ENCLOSURE 4

NAPS EAL SCHEME REVISIONS

**Virginia Electric and Power Company
(Dominion Energy Virginia)
North Anna Power Station Units 1 and 2 and ISFSIs**

**North Anna Power Station
NEI 99-01, Revision 6
EAL Comparison Matrix**

Figure 1: Containment Integrity or Bypass Examples

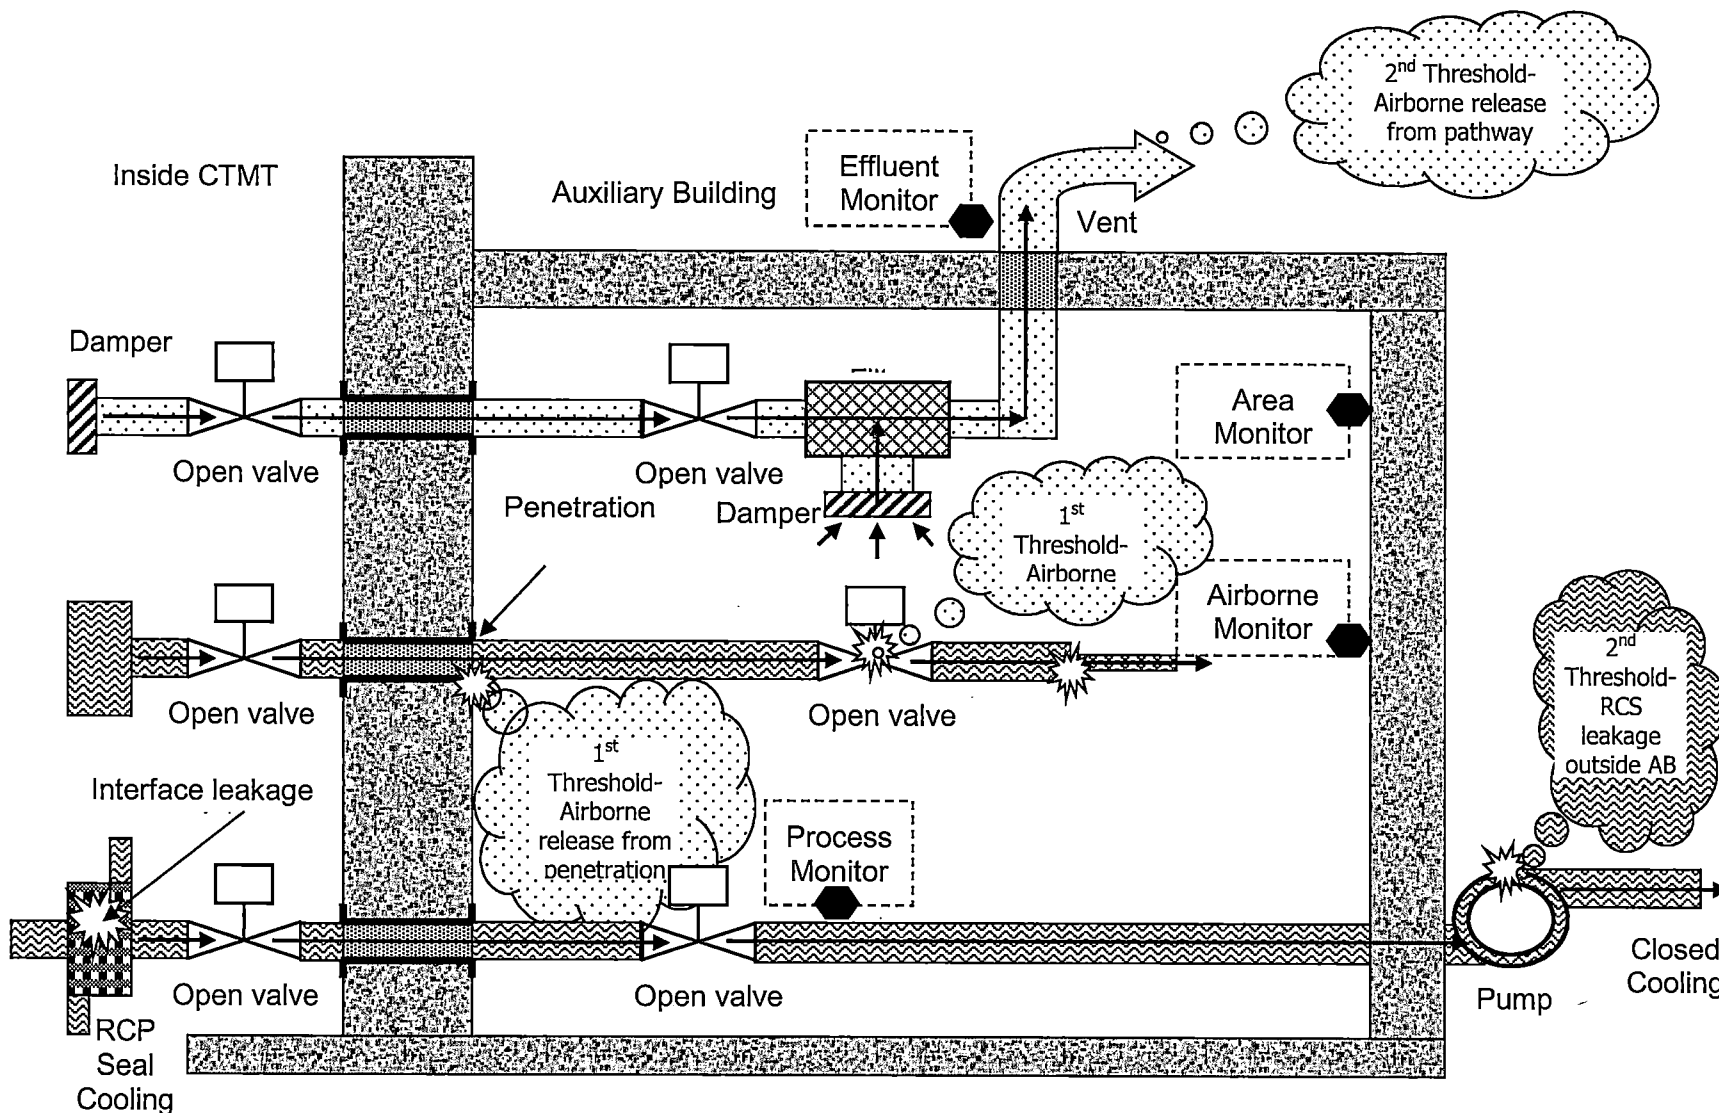
Refer to the middle piping run of Figure 9-F-41. Two simplified examples are provided. One is leakage from a penetration and the other is leakage from an in-service system valve. Depending upon radiation monitor locations and sensitivities, the leakage could be detected by any of the four monitors depicted in the figure.

Refer to the top piping run of Figure 9-F-41. In this simplified example, the inboard and outboard isolation valves remained open after a containment isolation was required (i.e., containment isolation was not successful). There is now an UNISOLABLE pathway from the containment to the environment.

Refer to the bottom piping run of Figure 9-F-41. In this simplified example, leakage in an RCP seal cooler is allowing radioactive material to enter the Auxiliary Building. The radioactivity would be detected by the Process Monitor. If there is no leakage from the closed water cooling system to the Auxiliary Building, then no threshold has been met. If the pump developed a leak that allowed steam/water to enter the Auxiliary Building, then the second threshold 4.B would be met. Depending upon radiation monitor locations and sensitivities, this leakage could be detected by any of the four monitors depicted in the figure and cause the first threshold 4.A.1 to be met as well.

Refer to the middle piping run of Figure 9-F-41. In this simplified example, a leak has occurred at a reducer on a pipe carrying reactor coolant in the Auxiliary Building. Depending upon radiation monitor locations and sensitivities, the leakage could be detected by any of the four monitors depicted in the figure and cause loss threshold 4.A.1D.2 to be met as well.

Figure 1: Containment Integrity or Bypass Examples

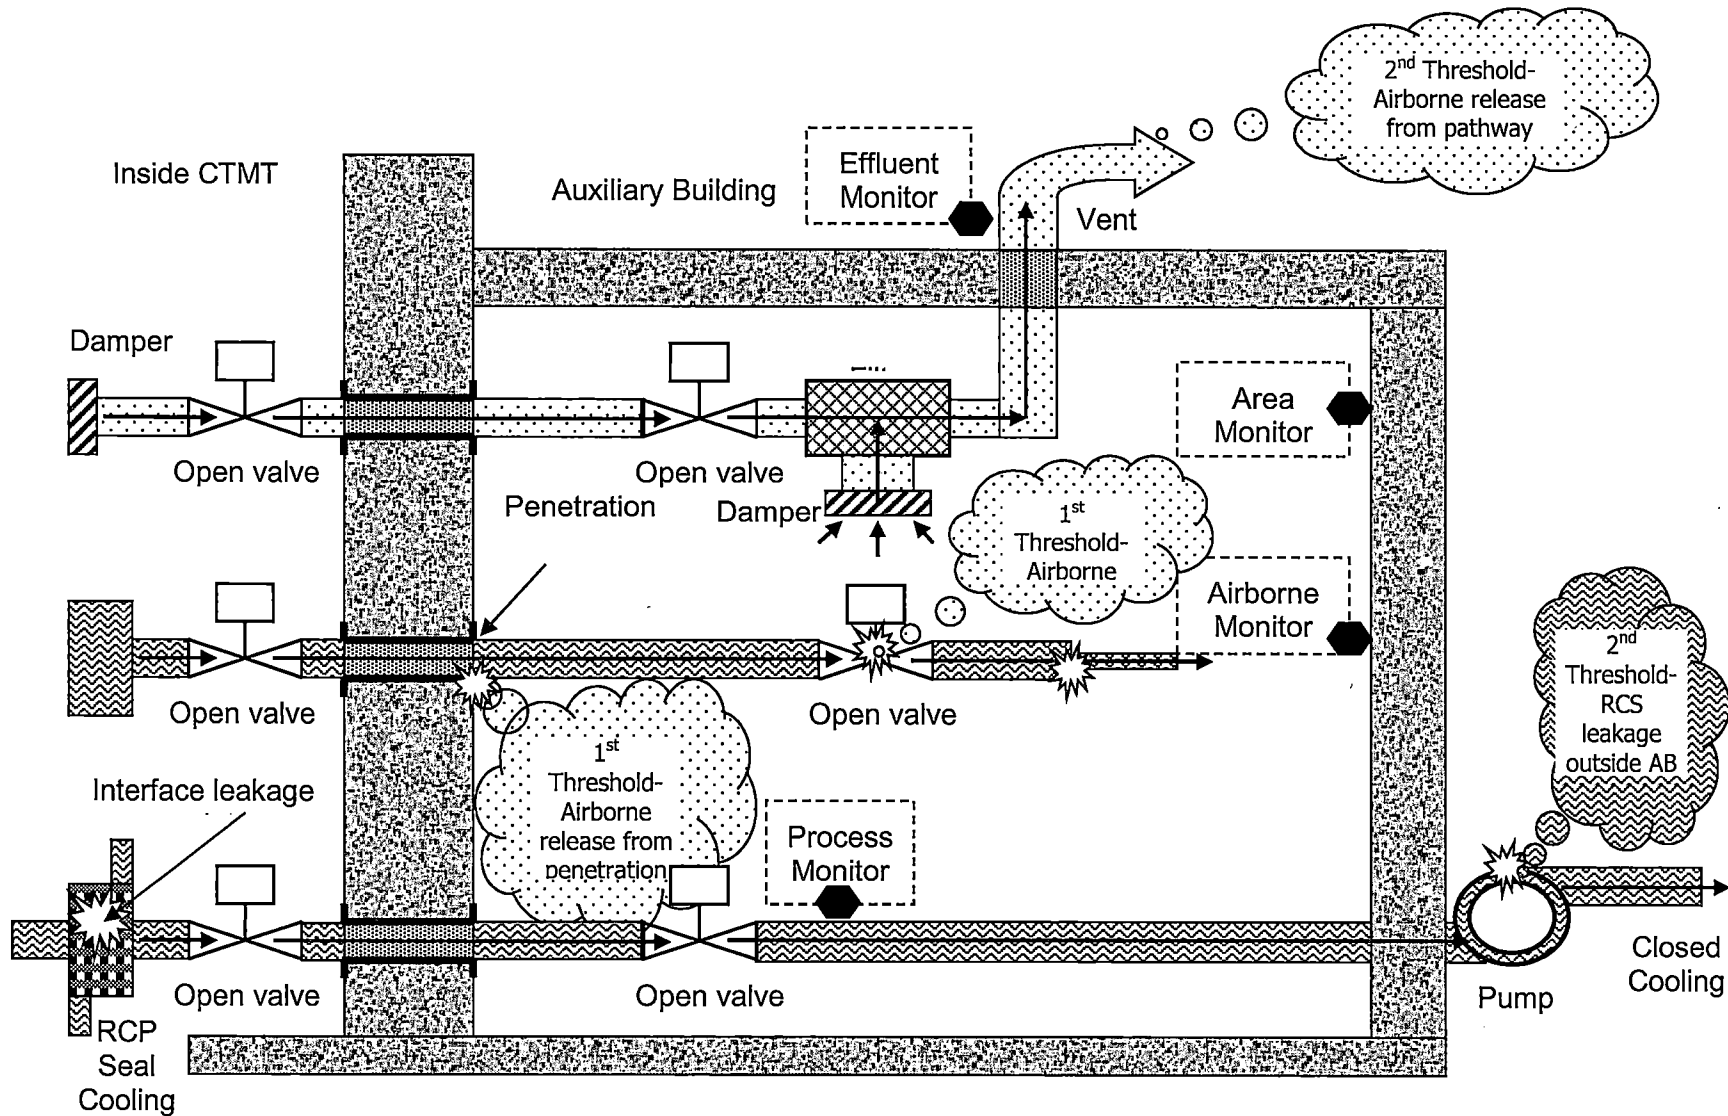
Refer to the middle piping run of Figure 1. Two simplified examples are provided. One is leakage from a penetration and the other is leakage from an in-service system valve. Depending upon radiation monitor locations and sensitivities, the leakage could be detected by any of the four monitors depicted in the figure.

Refer to the top piping run of Figure 1. In this simplified example, the inboard and outboard isolation valves remained open after a containment isolation was required (i.e., containment isolation was not successful). There is now an UNISOLABLE pathway from the containment to the environment.

Refer to the bottom piping run of Figure 1. In this simplified example, leakage in an RCP seal cooler is allowing radioactive material to enter the Auxiliary Building. The radioactivity would be detected by the Process Monitor. If there is no leakage from the closed water cooling system to the Auxiliary Building, then no threshold has been met. If the pump developed a leak that allowed steam/water to enter the Auxiliary Building, then the second threshold would be met. Depending upon radiation monitor locations and sensitivities, this leakage could be detected by any of the four monitors depicted in the figure and cause the first threshold to be met as well.

Refer to the middle piping run of Figure 1. In this simplified example, a leak has occurred at a reducer on a pipe carrying reactor coolant in the Auxiliary Building. Depending upon radiation monitor locations and sensitivities, the leakage could be detected by any of the four monitors depicted in the figure and cause loss threshold D.2 to be met as well.
